UNITED STATES PATENT AND TRADEMARK OFFICE

10/672,526

Office Action Summary

DAVIS, JAMES DARRIN

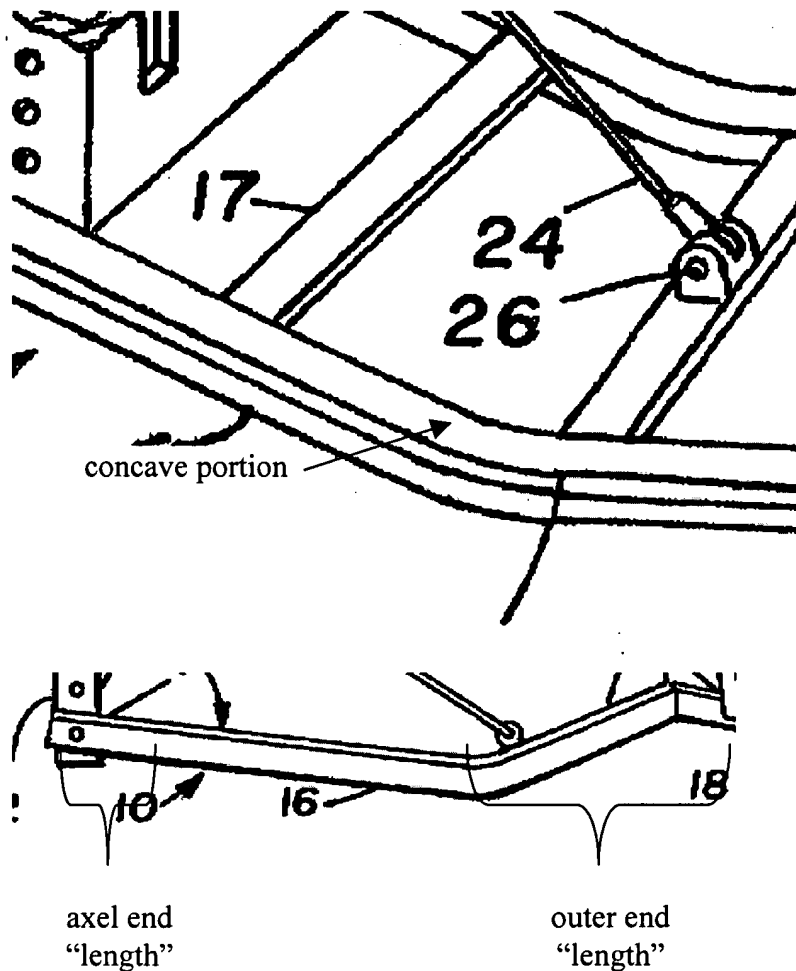
Claims 4, 9 & 14 are rejected under 35 U.S.C. 102(a) as being anticipated by Smith et al. (US 2002/0168257) (previously cited).

With respect to claims 4, 9 & 14, Smith et al. disclose a deer-carrier rack comprising an attaching frame 12 configured for attaching in an upright orientation (FIG. 2) to an end of an all-terrain vehicle, the attaching frame having a lower end and an upper end; and a deer support frame comprising spaced apart left 16 (or 15) and right 15 (or 16) generally co-extensive elongate dog leg rods, each of the rods having an axel end (see below) rotatably attached to the lower end of the attaching frame 12 for generally upward and downward rotation of the deer support frame relative thereto, and an outer end (see below) opposite the axel end and spaced from the lower end of the attaching frame, the outer end of each of the rods having a length which is at least two times greater than a length of the axel end thereof, and the axel ends of the rods forming a concave region adjacent to the lower end of the attaching frame, the concave region being configured and oriented so as to face upwardly while extending downwardly to the outer end of the rod when the attaching frame is attached in the upright orientation to an end of an all terrain vehicle and the deer support frame is rotatably positioned relative thereto in a deployed position extending outwardly

therefrom, the upwardly facing concave region being having a flat outer end which smoothly transitions into the outer end of the rods forming an at least substantially flat, unobstructed platform configured for receiving a body of a deer thereon such that the deer support frame with a body of a deer received on the flat platform can be rotated upwardly from the deployed position to an upright position wherein the outer ends of the rods extend at least generally vertically and the concave region is spaced outwardly from the lower end of the attaching frame for supporting the body of a deer thereagainst without pinching the body of the deer. during the upward rotation, and such that the deer support frame in the upright position can be secured to the attaching frame or the all terrain vehicle for holding the body of the deer against the lower end of the attaching frame.

While Applicant claims an axel end having a concave region and also claims a length (half the length of an outer end length) Applicants figure 5 makes clear that a concave region is part of the axel end. Thus, given the broadest reasonable interpretation the Examiner interprets the axel end to include both a "concave region" and a "length" and combined they comprise the whole of the axel end. A similar analysis of Ellis follows below.
